Access Compliance Report

Public Rights-of-Way

Intersection ID: 48988	Main Street: AVONCLIFF_DR	Cross Street: SMITHFIELD_DR	Location: NW
ADA ID: 2B02710415D5	Ramp Type: BlendTrans1	Initial Pass/Fail: Pass	Overall Compliance: No
Severity Score: 5			
Codes/Mitigation Info/Possible Solution		Field Measurements/Component Compliance

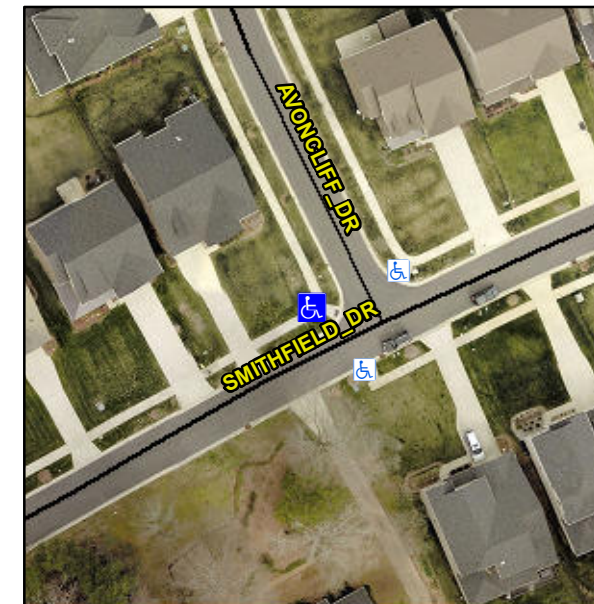
Not Found, R304.5.3, R305.2, R304.5.4

Compliance	Description	Data	Compliance	Description	Data
N/A	Ramp Length (in)	104.0	Yes	BlendTrans Slope (%)	1.6
Yes	Ramp Width (in)	48.0	Yes	BlendTrans XSlope (%)	1.1
N/A	Flare Type LT	Sloped	N/A	Flare Type RT	Sloped
N/A	Flare Slope LT (%)	5.2	N/A	Flare Slope RT (%)	6.2
N/A	Flare Traversable LT?	No	N/A	Flare Traversable RT?	No
Yes	Landing Length (in)	69.5	Yes	DWS Provided?	Yes
Yes	Landing Width (in)	48.0	Yes	DWS Contrast?	Yes
Yes	Landing Slope (%)	0.2	Yes	DWS Length (in)	24.0
No	Landing X Slope (%)	2.1	Yes	DWS Full Width?	Yes
N/A	Landing Curb? (Y/N)	No	No	DWS Offset (in)	5.5
N/A	Shared Landing?	No			
Yes	Gutter Ponding?	No	No	Gutter Slope (%)	11.4
Yes	Gutter Lip Ht (in)	0.0	Yes	Gutter X Slope (%)	0.2
N/A	Painted X Walk1?	No	N/A	Painted X Walk2?	No
	X Walk 1 Direction	To SE		X Walk 2 Direction	To NE
	X Walk 1 Width (in)	N/A		X Walk 2 Width (in)	N/A
	X Walk 1 Slope (%)	3.4		X Walk 2 Slope (%)	1.2
	X Walk 1 X Slope (%)	1.6		X Walk 2 X Slope (%)	2.8

N/A	Ramp inside XWalk1?	N/A	N/A	Ramp inside XWalk2?	N/A
	Road Slope (%)	0.5		Clear Space?	Yes
	Road X Slope (%)	1.8	N/A	Clear Space to XWalk (in)	N/A
Yes	Any Obstructions?	No	Yes	Storm Grate/Utility Hazard?	No
	Obstruction Type			Storm Grate/Utility Type	
		N/A			N/A
			Yes	Surface Condition? (G/P)	Good
			No	Curb Slope (%)	5.7

Remove & Replace Curb Ramp With Two New Directional Ramps or Equivalent. Remove & Replace Gutter.
